January 24, 2023

**Re: Sunset Apartment
SE Corner of Sunset Gardens Rd. & 86th St.
Traffic Circulation Layout
Engineer's Stamp 12-21-22 (L10-D032)**

TRAFFIC CIRCULATION
LAYOUT APPROVED

SUNSET APARTMENTS
ALBUQUERQUE, NM
TRAFFIC CIRCULATION LAYOUT

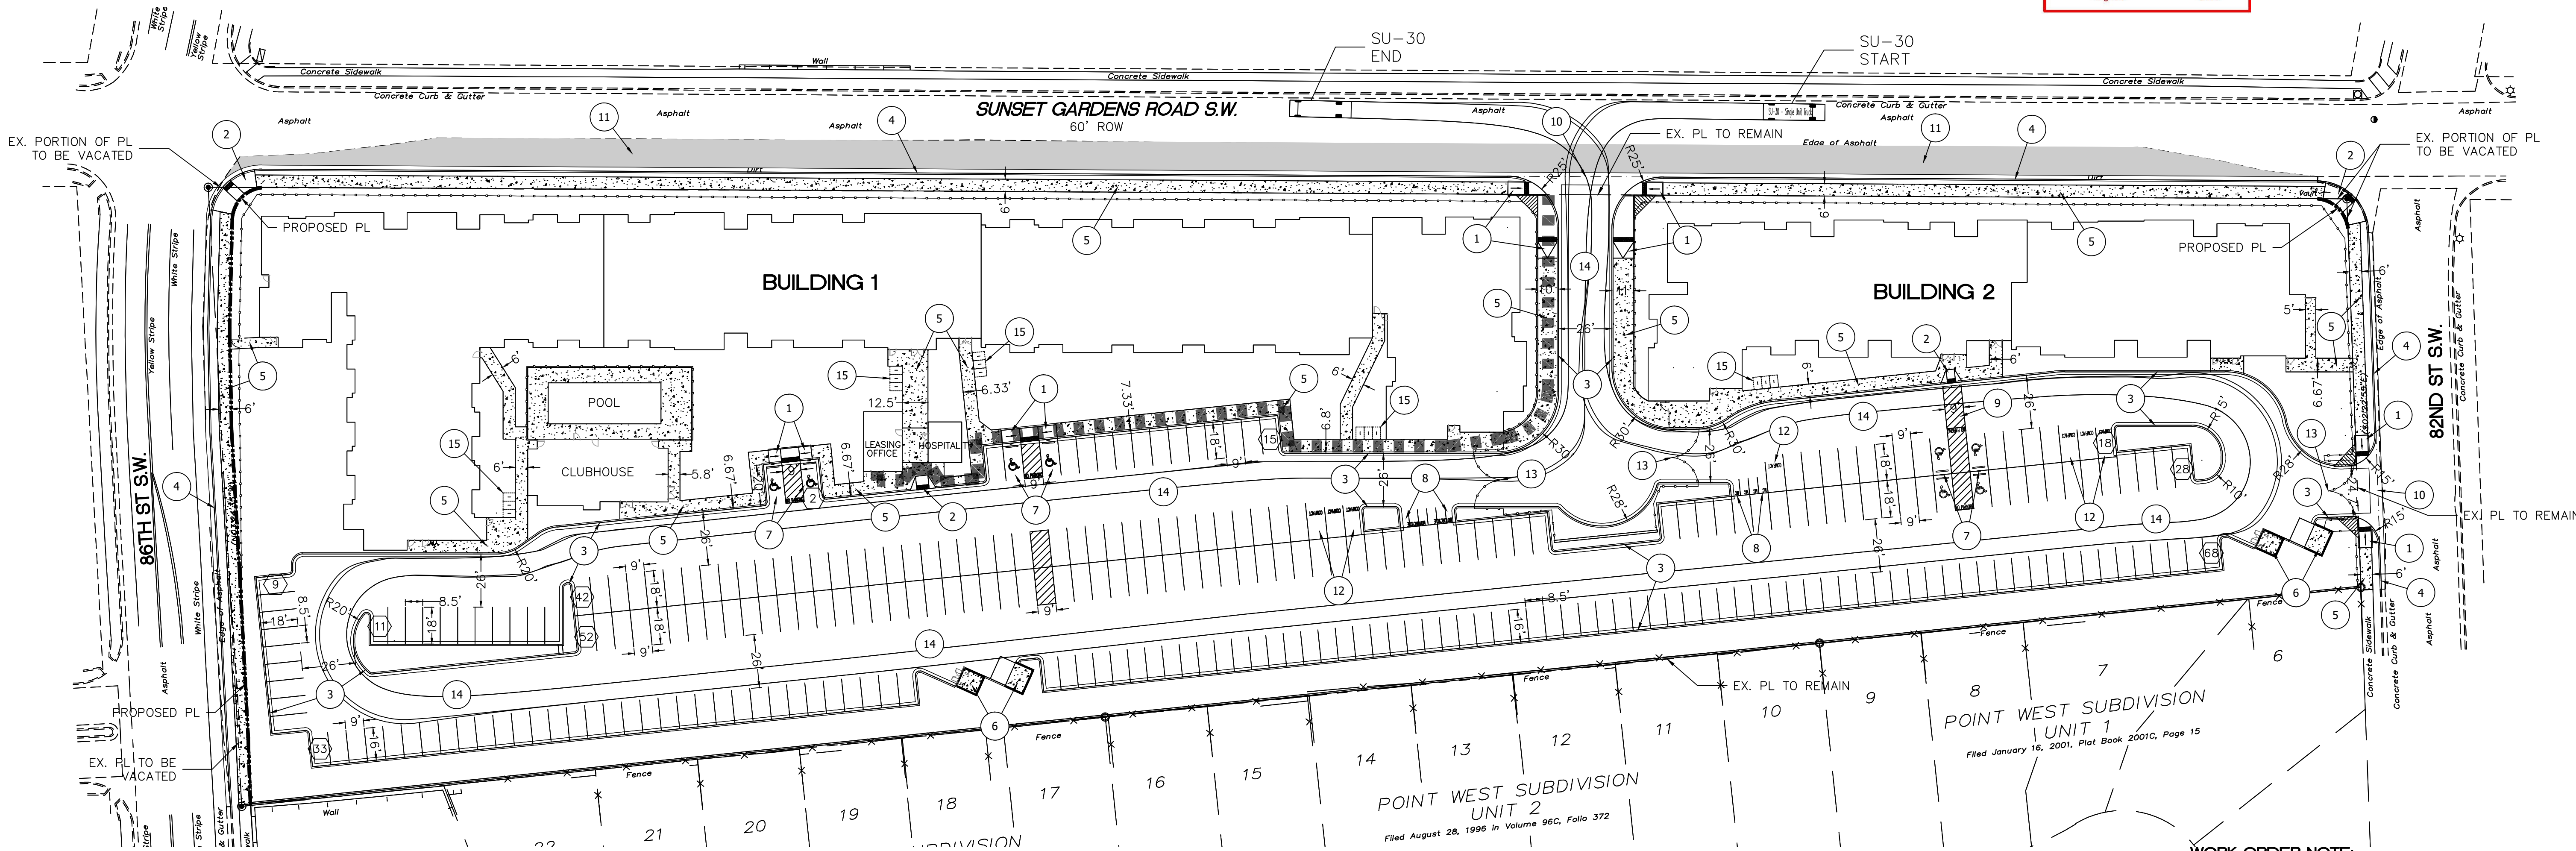
The TCL submittal received 12-28-2022 is approved for Building Permit by Transportation. A copy of the stamped and signed plan will be needed for each of the building permit plans. Please keep the original to be used for certification of the site for final C.O. for Transportation.

When the site construction is completed and an inspection for Certificate of Occupancy (C.O.) is requested, use the original City stamped approved TCL for certification. Redline any minor changes and adjustments that were made in the field. A NM registered architect or engineer must stamp, sign, and date the certification TCL along with indicating that the development was built in "substantial compliance" with the TCL. Submit this certification, the TCL, and a completed Drainage and Transportation Information Sheet to the PLNDRS@cabq.gov for log in and evaluation by Transportation. **An Approved/Accepted work order must be provided prior of final CO approval.**

An Approved/Accepted work order must be provided prior of final CO approval
